RE: **OSDS Plan- 3190 Daisy Road
Woodbine, MD 21797**

I have reviewed your OSDS for 3190 Daisy Road and revisions are needed. On your OSDS plan the following needs to be addressed:

ON-SITE SEWAGE DISPOSAL SYSTEM DESIGN PLAN

2000 GALLON CAPACITY SEPTIC TANK
MANUFACTURER: **OLDCASTLE**
www.oldcastleprecast.com

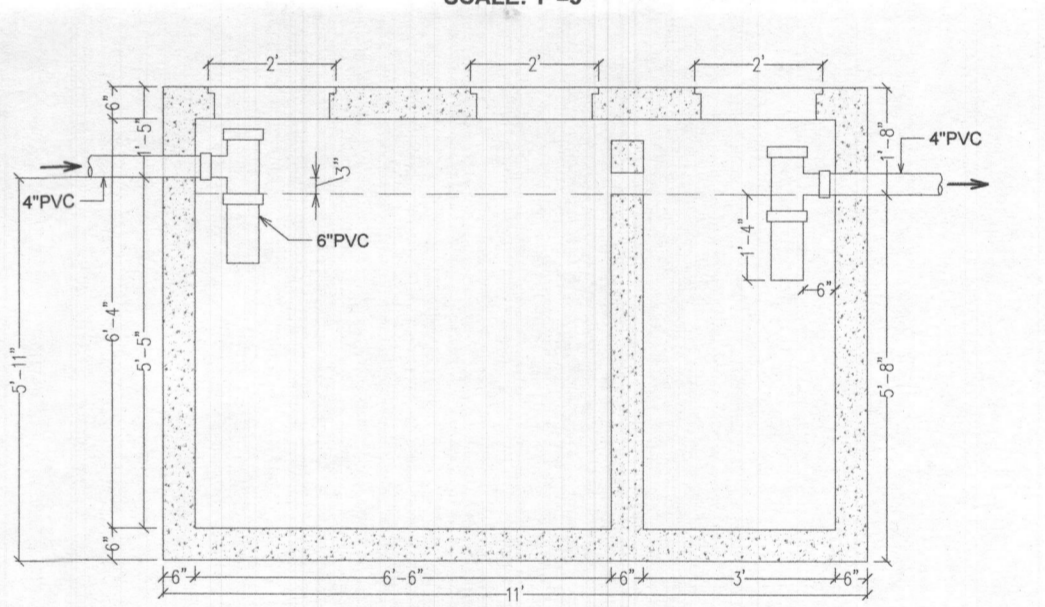
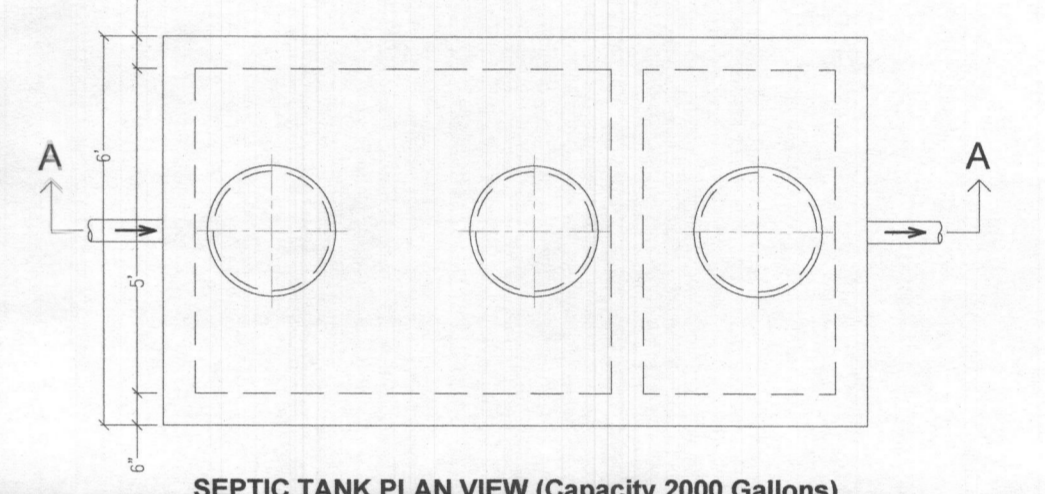
- The tank schematic shown cannot be used according to our current regulations. We have not worked with Old Castle Precast and when I tried to visit the website to see what products and services they supply, the site was not available. We use tank providers who design tanks according to our regulations. A few companies we use is Mayor Brothers, Backriver Precast, and Babylon Precast. Please note I am not recommending them, however I wanted to give you an idea of which companies we normally work with.

Note: I have attached the Howard County Regulations for your convenience. Visit Sec 3.810 and review (c.) Septic Tank Construction and (d.) Septic Tank Installation Requirements.

2000 GALLON CAPACITY SEPTIC TANK
 MANUFACTURER: Mayer Brothers Inc
 www.mayerbroprecast.com
